<b>ITEM: 6.8</b>	<b>REPORT SUMMARY MINOR VARIANCE APPLICATION FILE NUMBER A143/24</b>
------------------	--

## MINOR VARIANCE APPLICATION FILE NUMBER A143/24

<b>CITY WARD #:</b>	3
<b>APPLICANT:</b>	Patrick Spanjers & Cynthia Diner-Spanjers
<b>AGENT:</b>	Nekisha Narine - Leeswood Construction
<b>PROPERTY:</b>	11 Johnswood Crescent, Woodbridge
<b>ZONING DESIGNATION:</b>	See below.
<b>VAUGHAN OFFICIAL PLAN (2010) DESIGNATION:</b>	Vaughan Official Plan 2010 ('VOP 2010'): "Low-Rise Residential"
<b>RELATED DEVELOPMENT APPLICATIONS:</b>	None
<b>PURPOSE OF APPLICATION:</b>	Relief from the Zoning By-law is being requested to permit a proposed cabana.

## 1 SITE PLAN

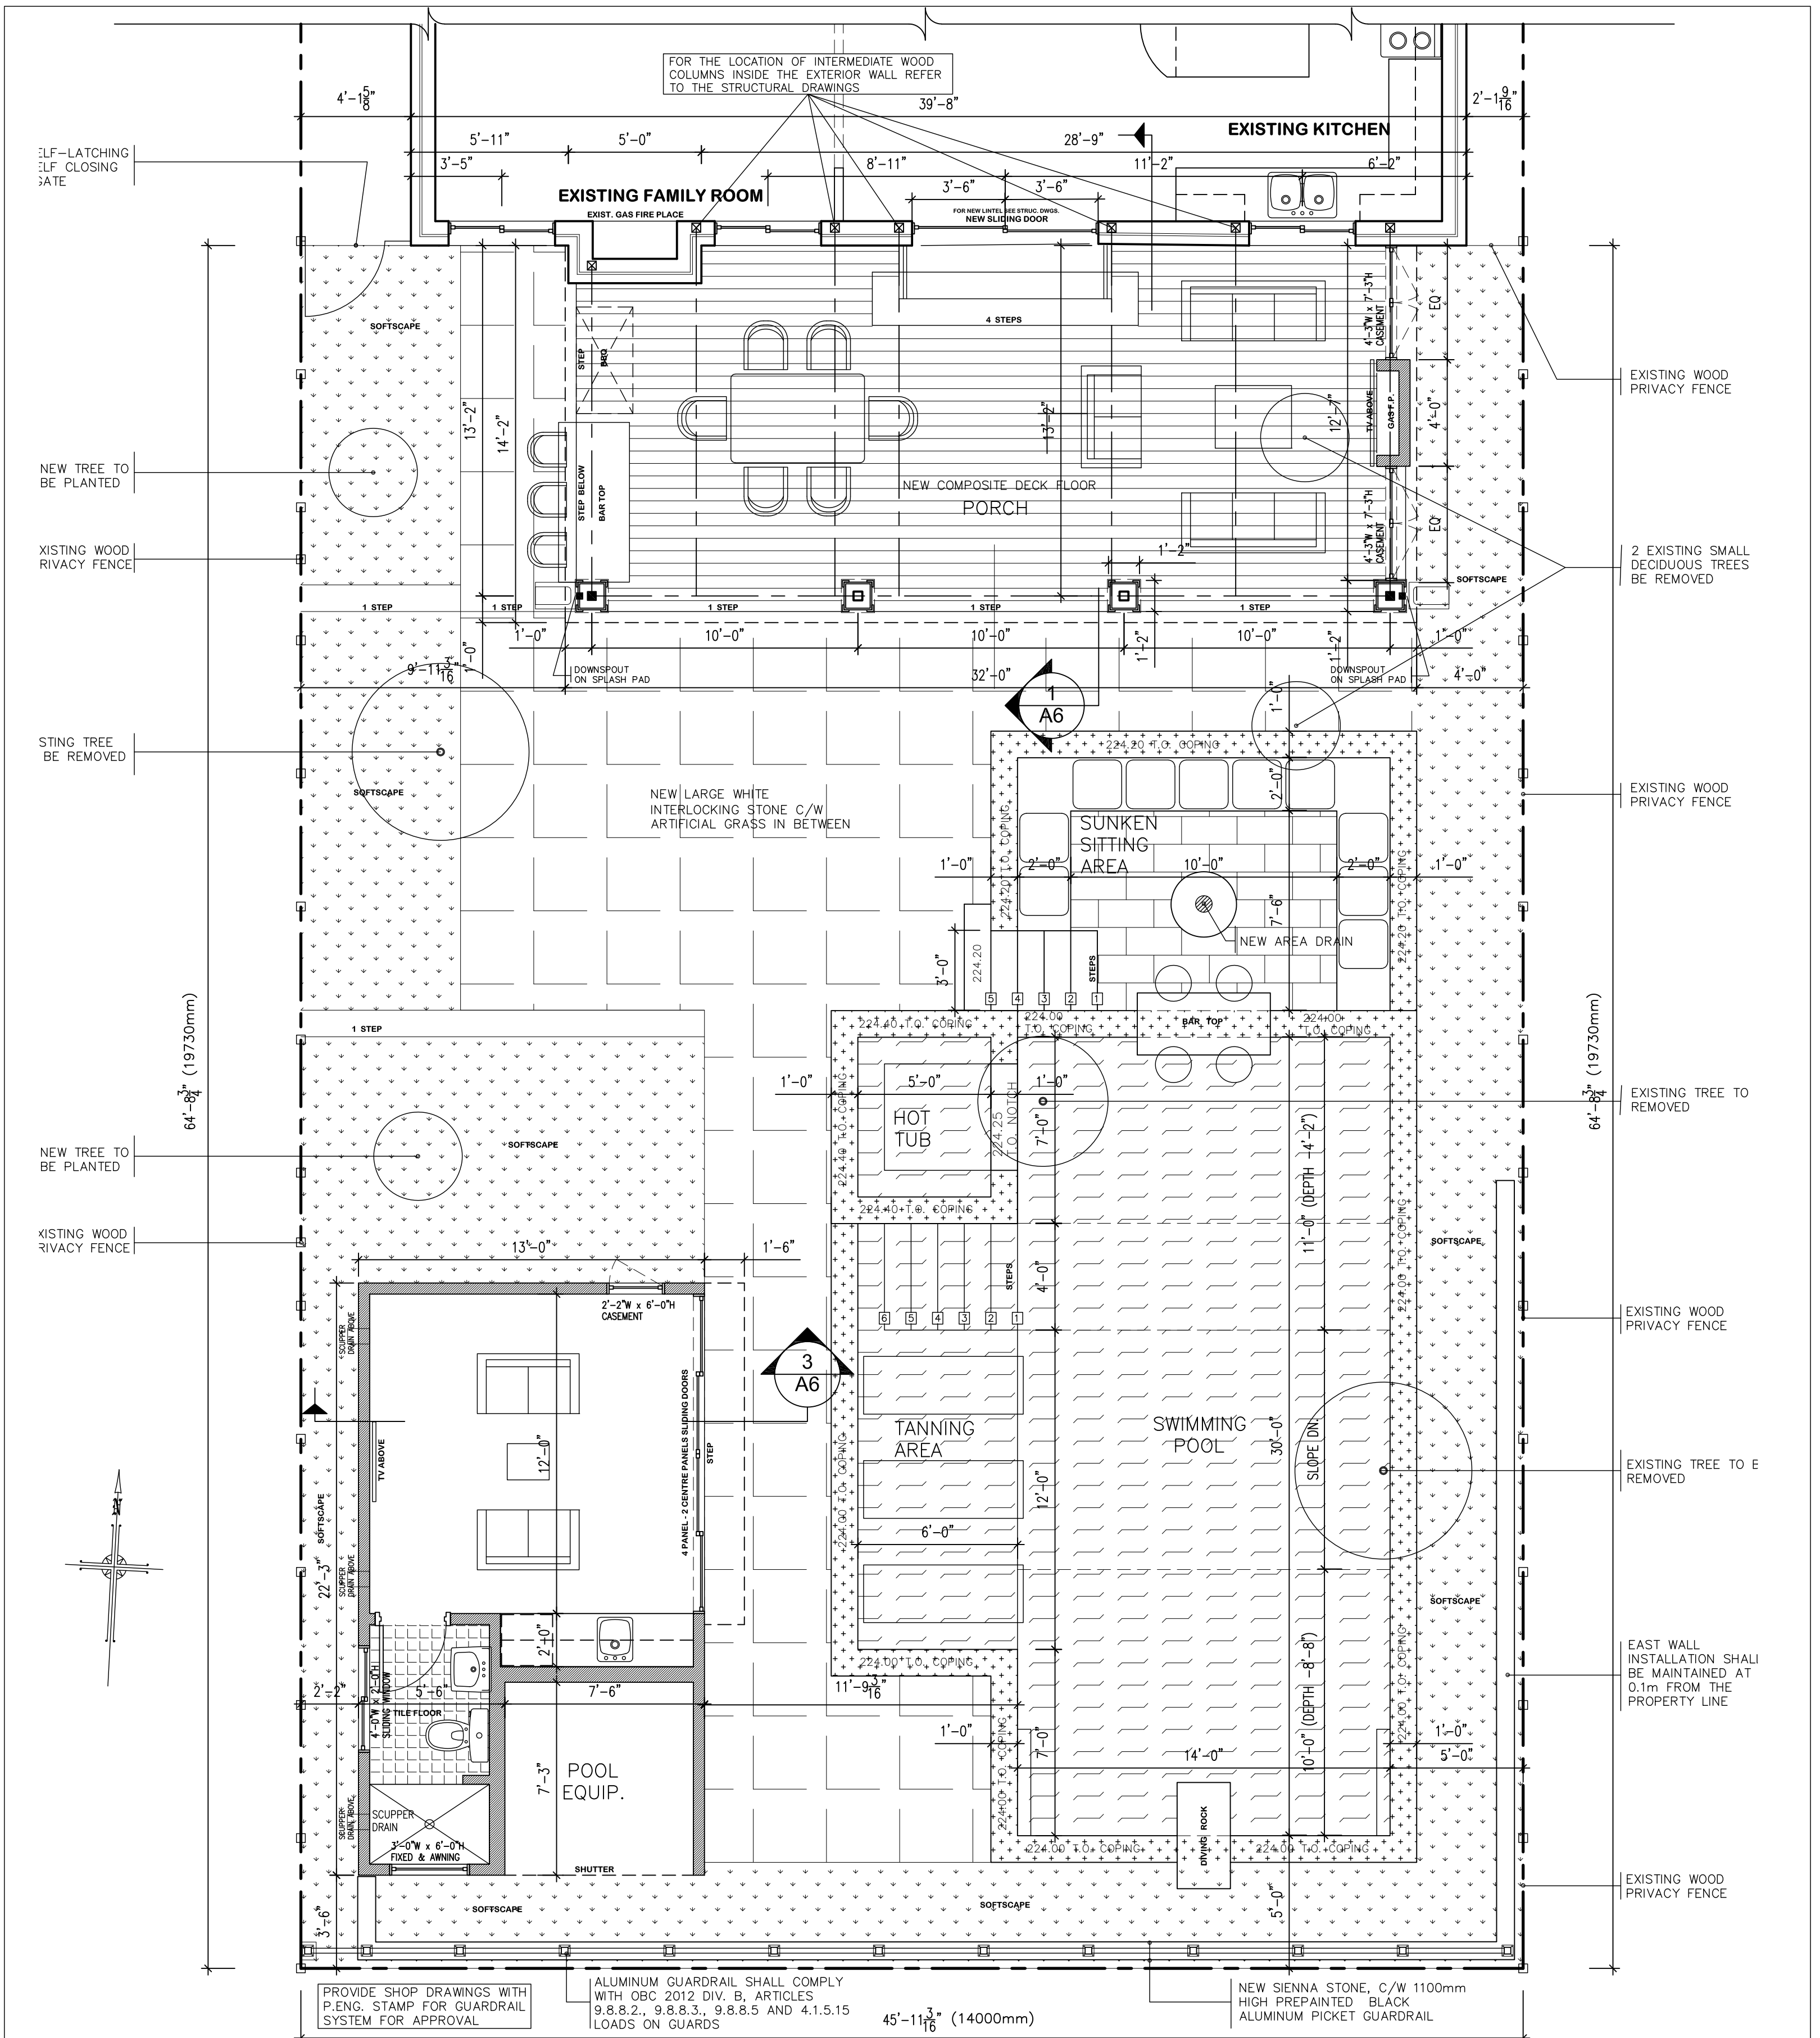
The Development Planning Department has no objection to Variances 1 and 2 for the proposed setback reductions from the cabana to the rear and west interior side lot lines. The cabana, proposed in the southwest corner of the rear yard, would be set back 0.65 m from the west interior side lot line and 1.06 m from the rear lot line. The proposed reduced setbacks provide sufficient spatial separation for access and maintenance. The Owners propose to remove an existing Norway Spruce tree and plant four (4) new replacement trees along the west interior side lot line. The four (4) replacement trees are located north of the proposed cabana, and will provide some additional screening between the cabana and neighbouring dwelling at 15 Johnswood Crescent in conjunction with the wood privacy fence. The proposed cabana is modest in building footprint, and complies with maximum lot coverage provisions. The City-owned Vellore Tract Woodlot is to the south. As such, the proposed cabana is not anticipated to incur adverse use (privacy) or massing impacts on the neighbouring property to the west (15 Johnswood Crescent) and or south (woodlot).

The Development Planning Department has no objection to Variance 4 to permit reduced minimum front yard soft landscaping. The Zoning By-law provision requires a minimum front yard landscaping of 50%, of which 60% is to be soft landscaping. The intent of the provision is to ensure that the front yard provides an adequate combination of hard and soft landscaping to allow for features like snow storage, stormwater attenuation, and mitigation of urban heat island effects. The existing front yard accommodates a variety of soft and hard landscaping features including trees, flower planters, and interlocking stones. The 4.63% reduction in soft landscaping represents an area of approximately 3.15 m<sup>2</sup>, which does not pose a significantly perceptible adverse impact on the front yard's appearance from the public realm nor significantly impact its function.

**MAIN BUILDING PART SIDE ELEVATIONS**  
**ACCESSORY BUILDING ELEVATIONS**

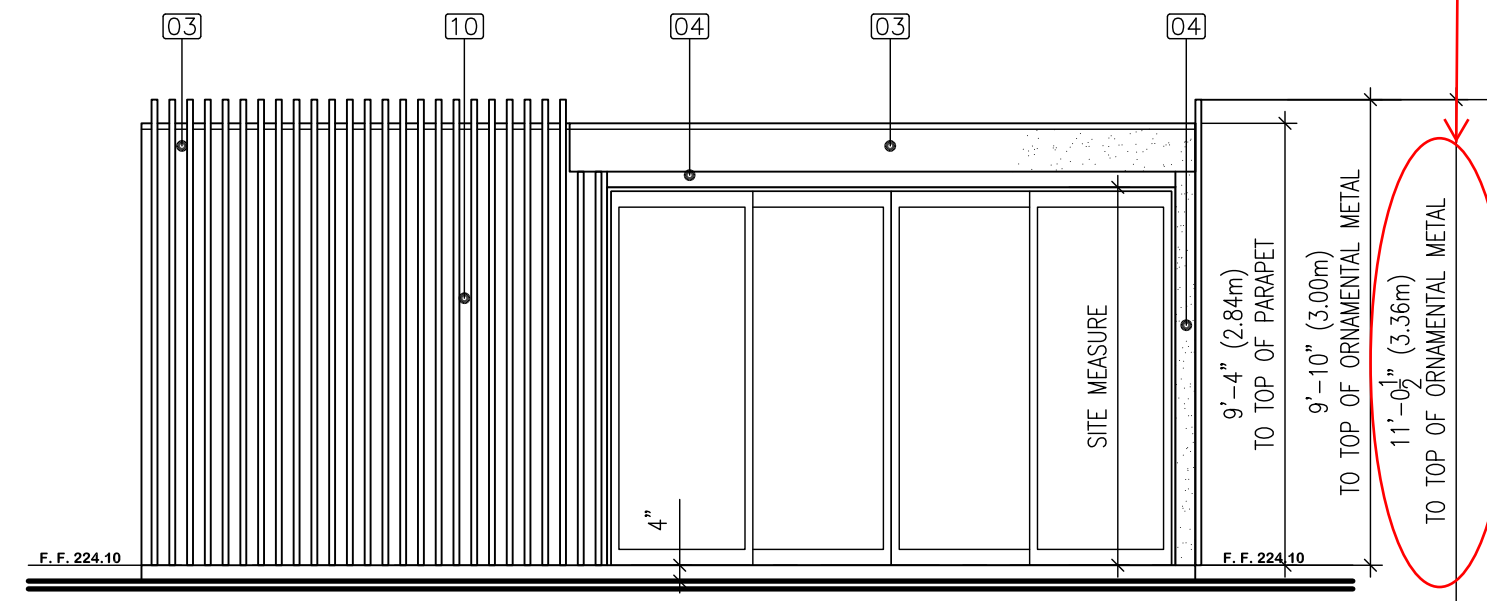
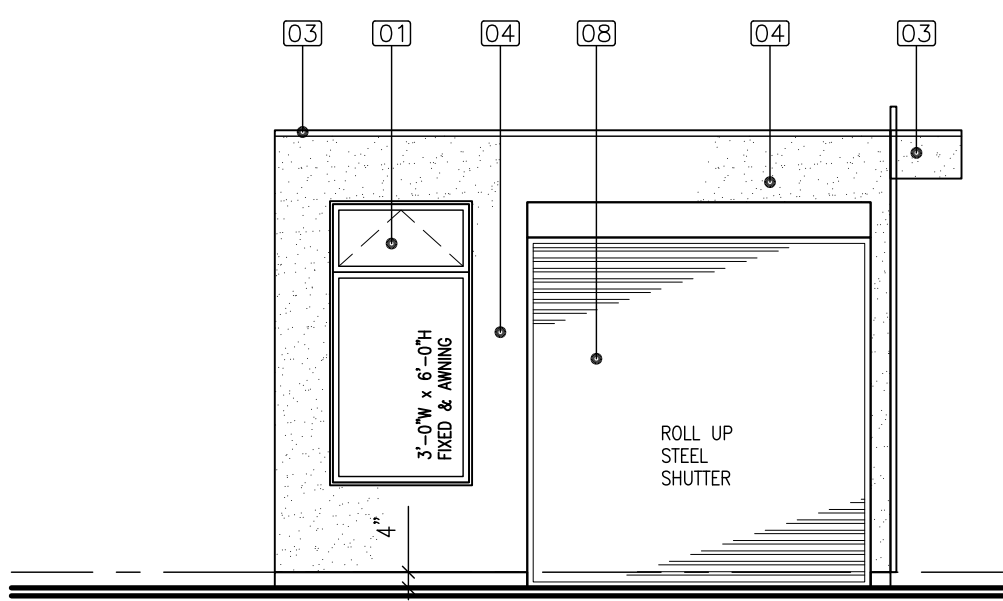
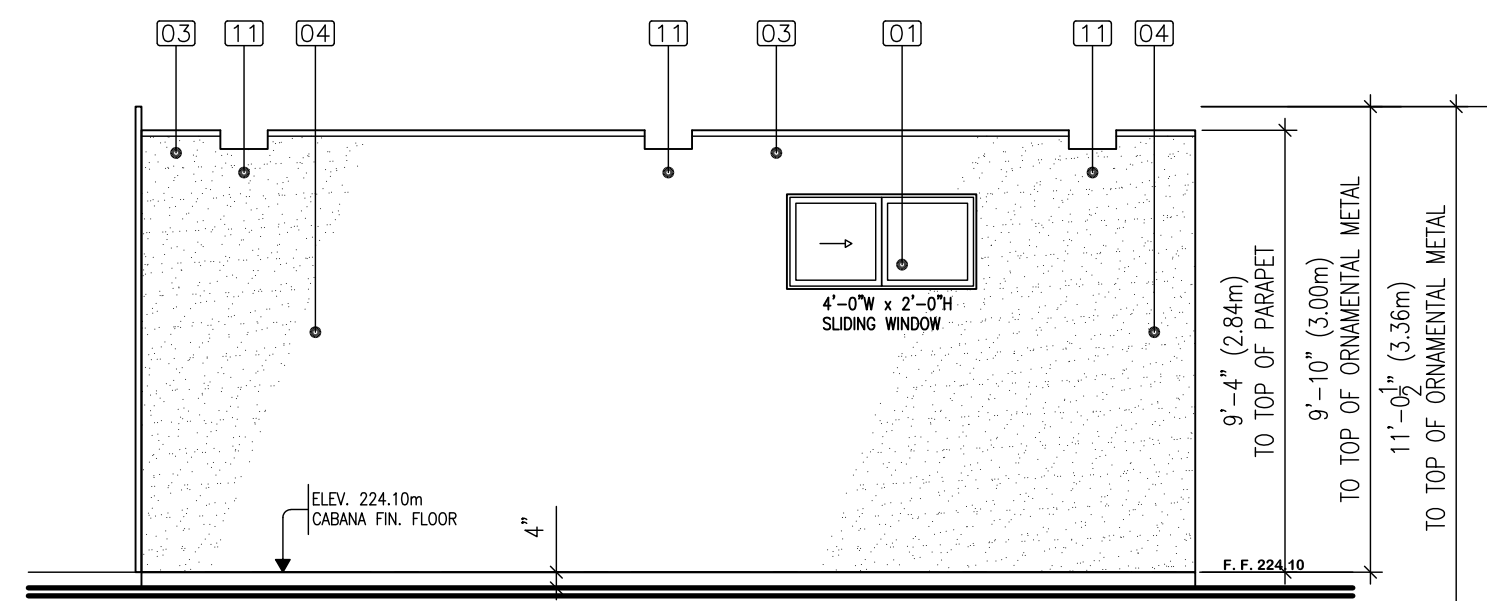
The Development Planning Department has no objection to Variance 3 to permit a cabana with a maximum height of 3.36 m. The proposed cabana has a flat roof, and the maximum height is measured from the average established grade to the top of the roof. The rear yard slopes downward towards the south, resulting in the cabana's slab becoming more exposed further south. This change in grade results in the average established grade calculation being taken approximately 0.36 m below the top of the concrete slab. If the height of the proposed cabana was taken from the top of the concrete slab, it would be 3.00 m, which complies with the Zoning By-law's height provision for accessory buildings.

Given that the added requested height will only be fully apparent on lands facing/near the south lot line, it is not anticipated that the added height will be perceptible.
